Recall Bulletin

SUBJECT: Front Axle Right Half Shaft Fracture

MODELS: 2013-2014 Chevrolet Cruze
Equipped with 1.4L Turbo Engine (LUV)

3924829

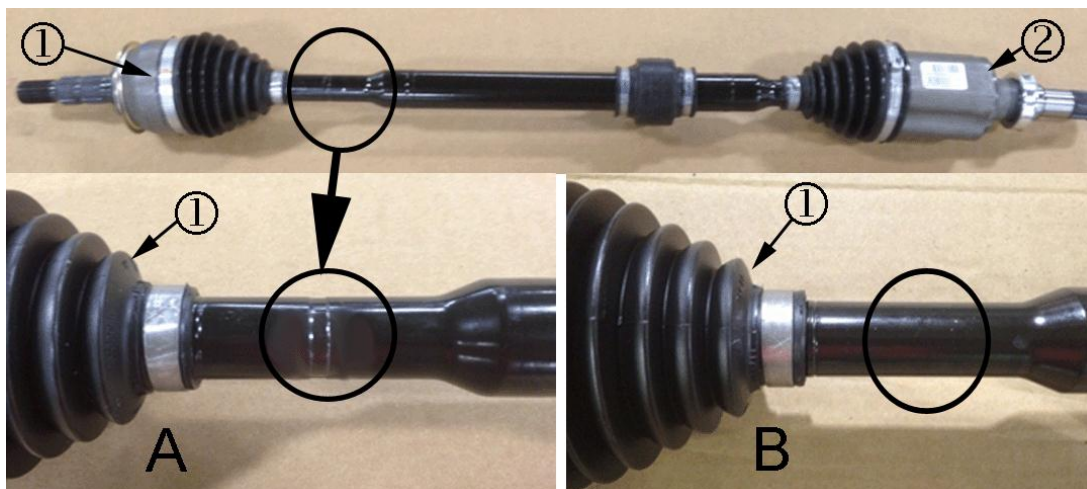
Service Part Number 13371620 (Manual Trans Tubular)

1. Inspect the inboard side of the shaft (shorter portion between rubber isolator and boot) for a green stripe, green dot or combination of green stripe and green dot.

- If one of these markings (3) are present, this is a good part.
- If there are no green markings on the inboard portion of the shaft (4) this part should be returned to General Motors under special return message G_0000187857 dated March 18, 2014 (US) or GMP 2014-073 dated March 17, 2014 (CN).

3773590

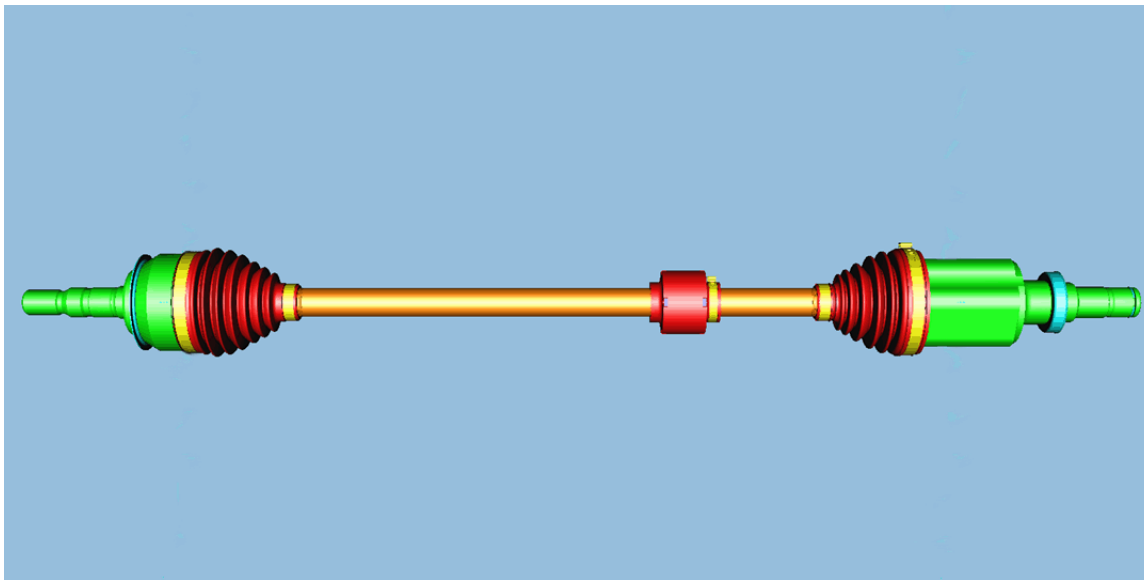
Service Part Number 13371628 (Auto Trans Tubular)

1. Inspect outboard side of the half shaft (longer portion of shaft between CV joint and isolator). Determine if a machined groove is present on the half shaft.
 - If the machined groove is present (A) on the half shaft, the part can be used for service.
 - If the machined groove is NOT present (B) on the half shaft, proceed to step 2.
2. Inspect the inboard side of the shaft (shorter portion between rubber isolator and boot) for a green stripe, green dot or combination of green stripe and green dot.
 - If these markings are present, this part can be used for service.
 - If no green strip, green dot, or green stripe and dot is present, this part should be returned to General Motors under special return message G_0000187857 dated March 18, 2014 (US) or GMP 2014-073 dated March 17, 2014 (CN).

3919719

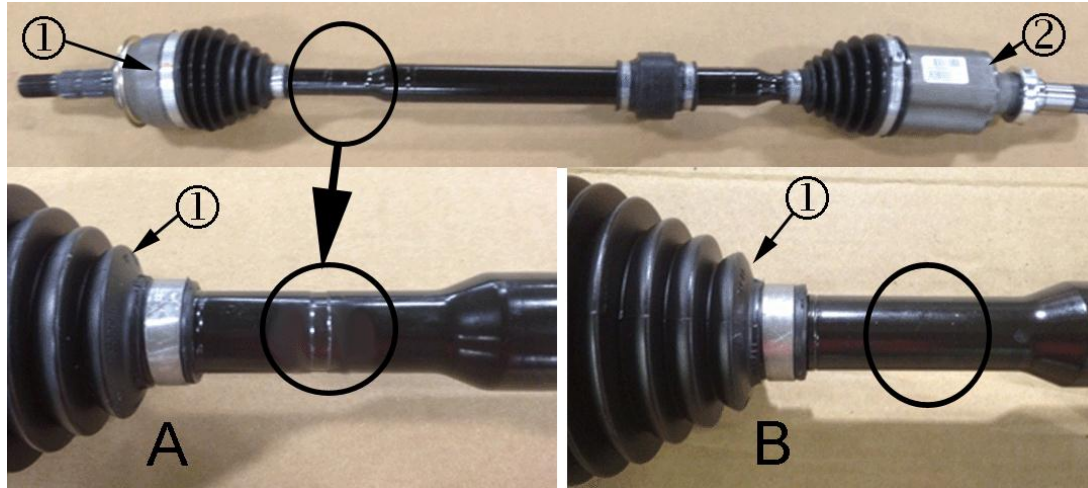
Service Part Number 13334705, 13367771, 13335132 (Auto Trans solid shaft) and 13367770 (Manual Trans solid shaft)

Note: Any additional paint marks found on a solid axle shaft can be disregarded.

1. The outboard side of the half shaft (longer portion of shaft between CV joint and isolator) is a solid painted bar shaft. Same diameter across entire shaft. There are no other identifications on the half shaft to look for. This part can be used for service.

3773590

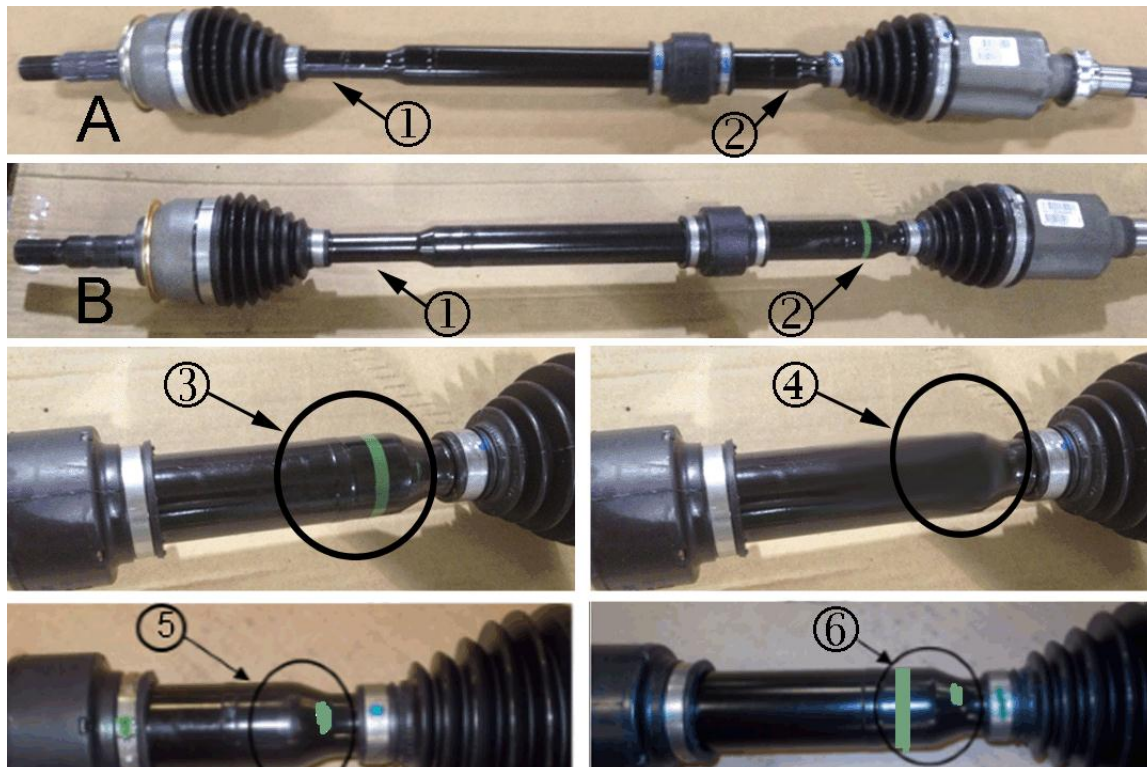
1. Raise and support the vehicle. Refer to *Lifting and Jacking the Vehicle* in SI.
2. Inspect the right (passenger side) half shaft near the front wheel. Determine if a machined groove is present on the half shaft.

(1) Wheel Side of Half Shaft (2) Transmission Side of Half Shaft (A) Machined Groove (B) No Groove

- If the machined groove is present (A) on the half shaft, no further action is required. Lower the vehicle.
 - If the machined groove is NOT present (B) on the half shaft, proceed to step 3.
3. Inspect the right (passenger side) half shaft near the transmission. Determine if a green stripe, green dot, or green stripe and green dot is present on the half shaft bar.
